NIAGARA MOHAWK POWER CORPORATION

DOCKET NO. 50-220

Proposed Changes to Technical Specifications (Appendix A)

### 3.3.2 PRESSURE SUPPRESSION SYSTEM PRESSURE AND SUPPRESSION CHAMBER WATER TEMPERATURE AND LEVEL

FIGURE 3.3.2 a

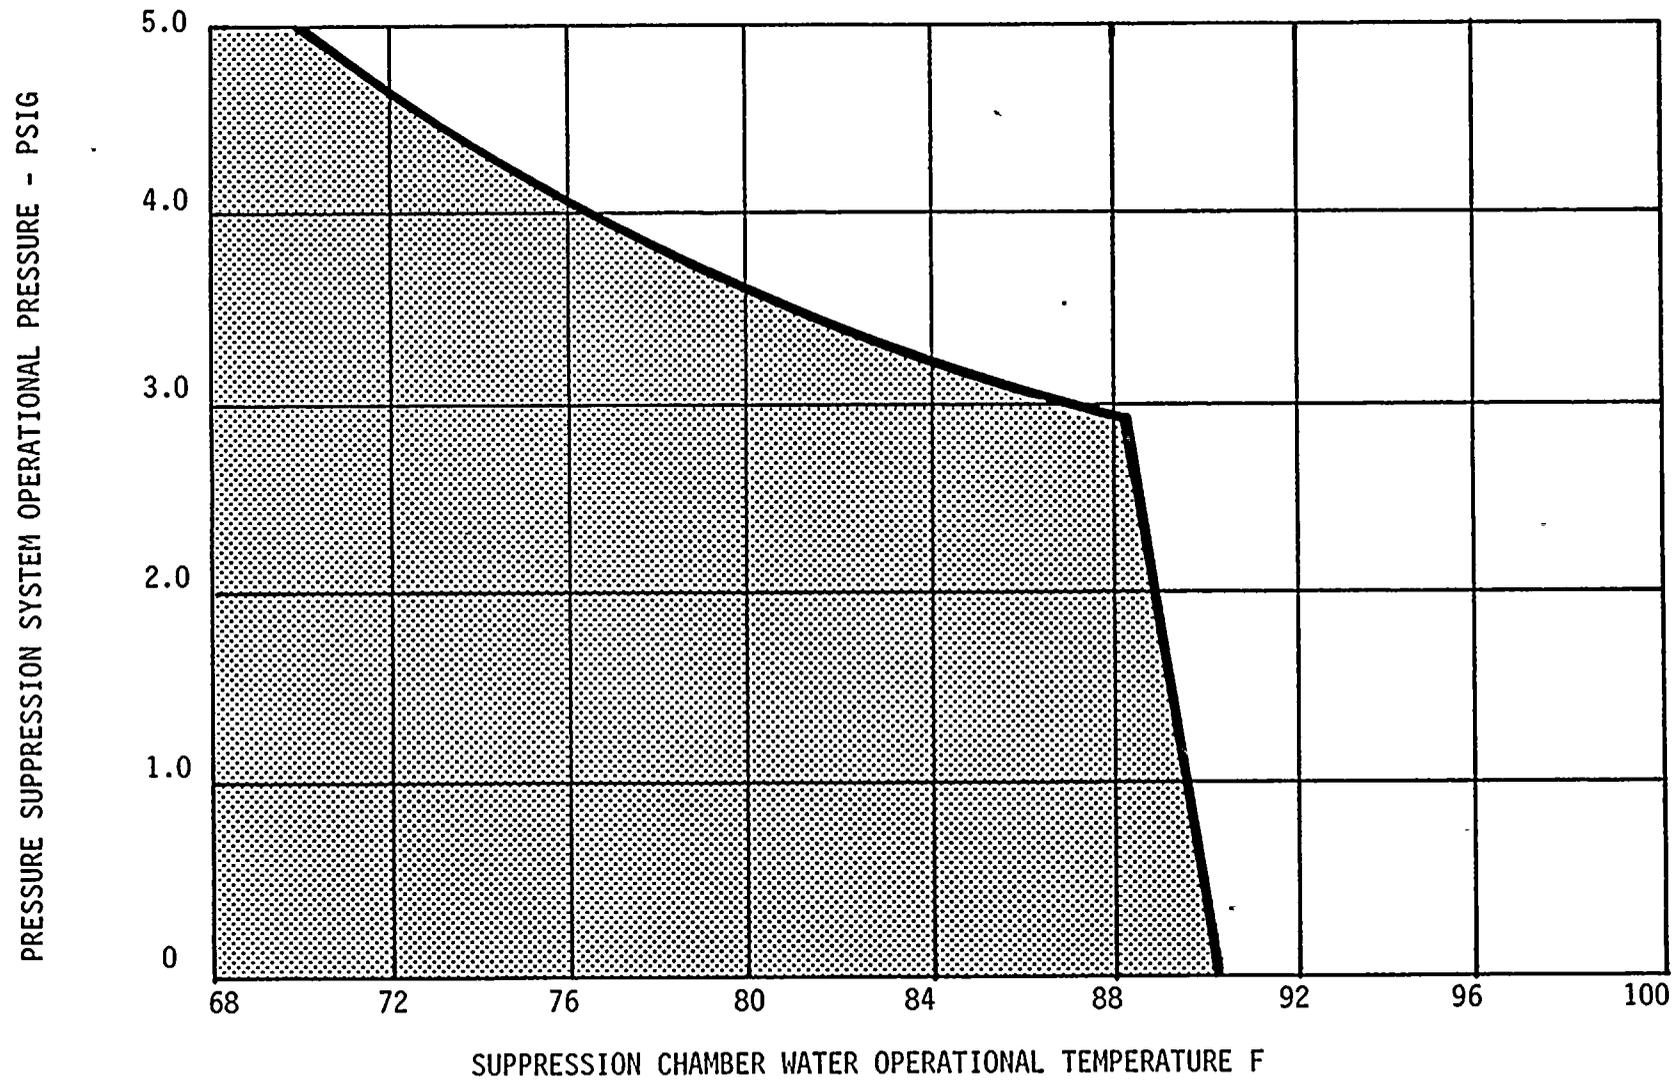
Figures 3.3.2.a and b have been revised to include the region from 0 to 2 psig initial pressure.

- (1) Figure 3.3.2a when downcomer submergence is greater than or equal to 4 feet, or (2) Figure 3.3.2b when downcomer submergence is greater than or equal to 3 feet but less than 4 feet. If these temperatures are exceeded, pool cooling shall be initiated immediately.
